Res # 425 W. Washington ST.

Joe Dilbone

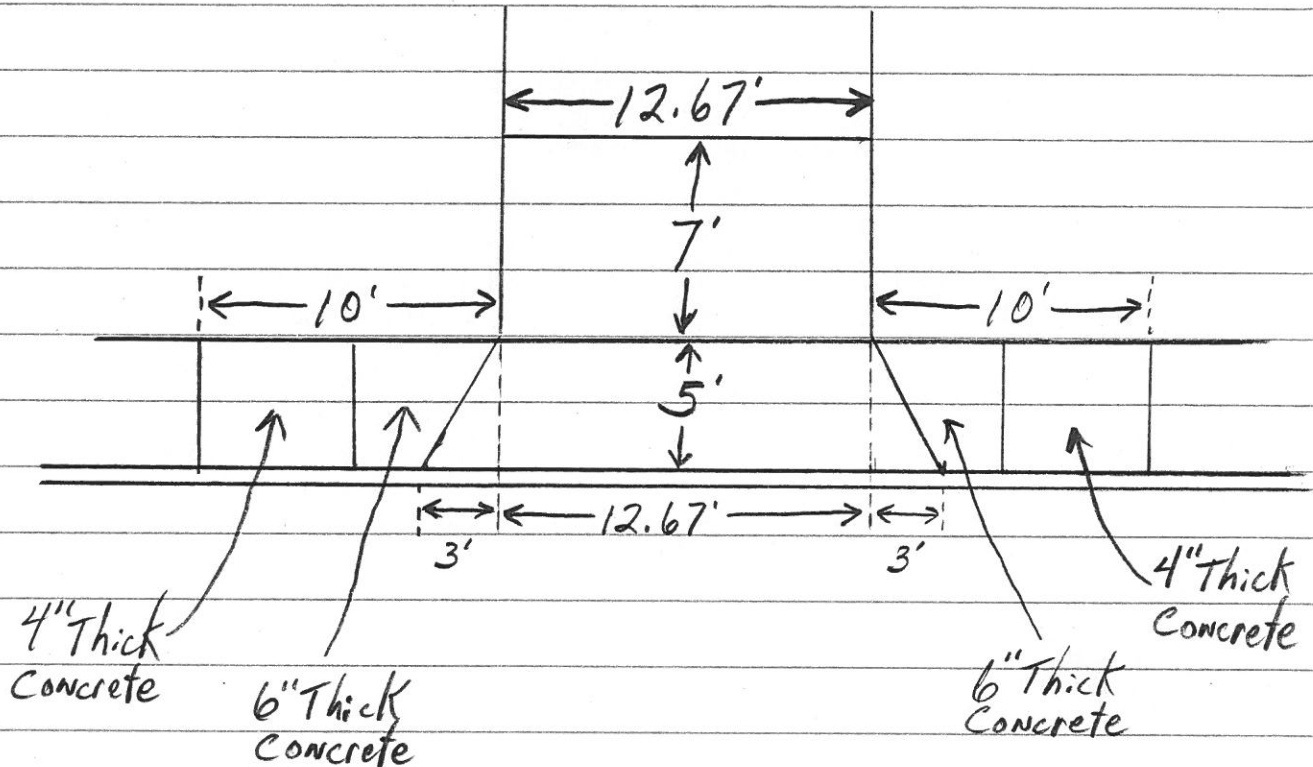
All of Drive Approach + Sidewalk, 5' l.t. on each side of Drive is to be 6" Thick concrete on 6" Thick #304 or #411 stone.

Sidewalk outside of these areas shall be 4" Thick Concrete on 4" Thick #304 or #411 stone

Type 6 curb shall be cut to match slope of drive approach, area directly in front of drive needs to be replaced with new Type 6 curb.

Res # 425 W. Washington ST.

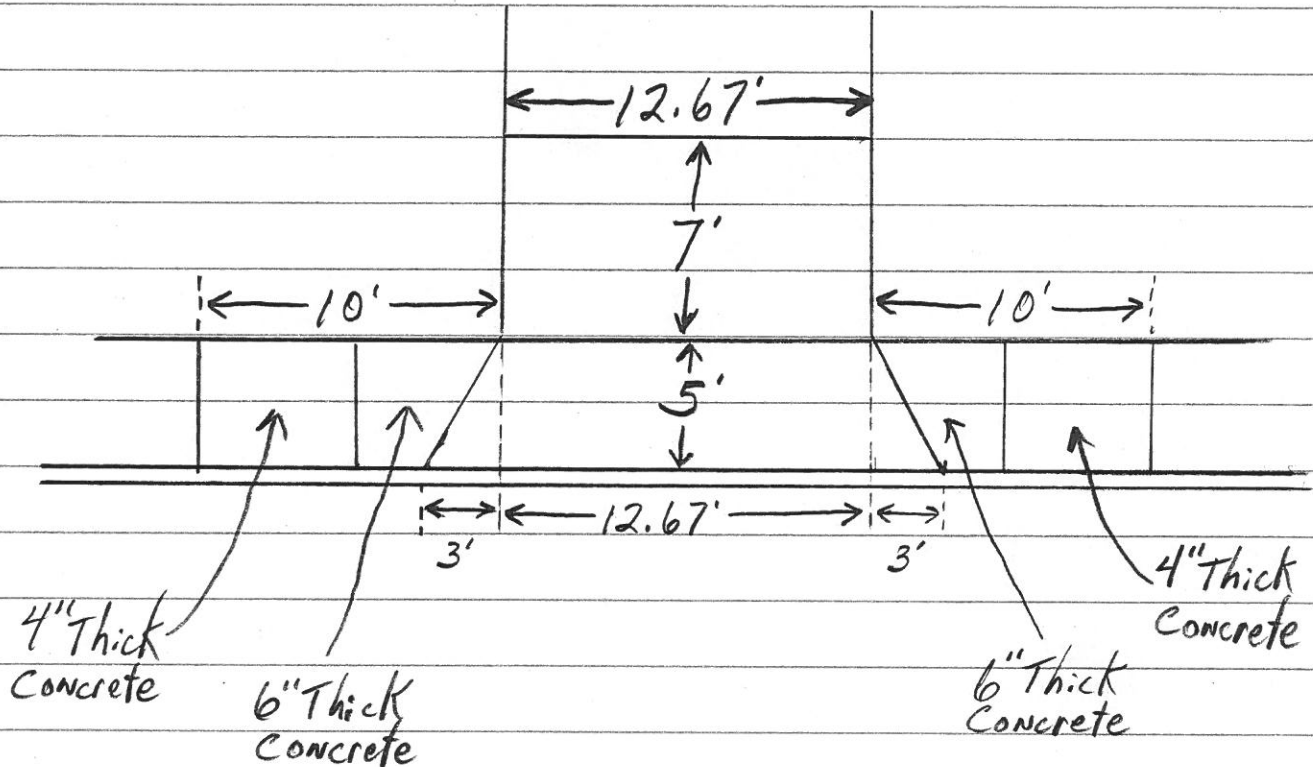
All of Drive Approach + sidewalk, 5' l.f. on each side of Drive is to be 6" Thick concrete on 6" Thick #304 or #411 stone.

Sidewalk outside of these areas shall be 4" Thick Concrete on 4" Thick #304 or #411 stone

Type 6 curb shall be cut to match slope of drive approach, area directly in front of drive needs to be replaced with new Type 6 curb.
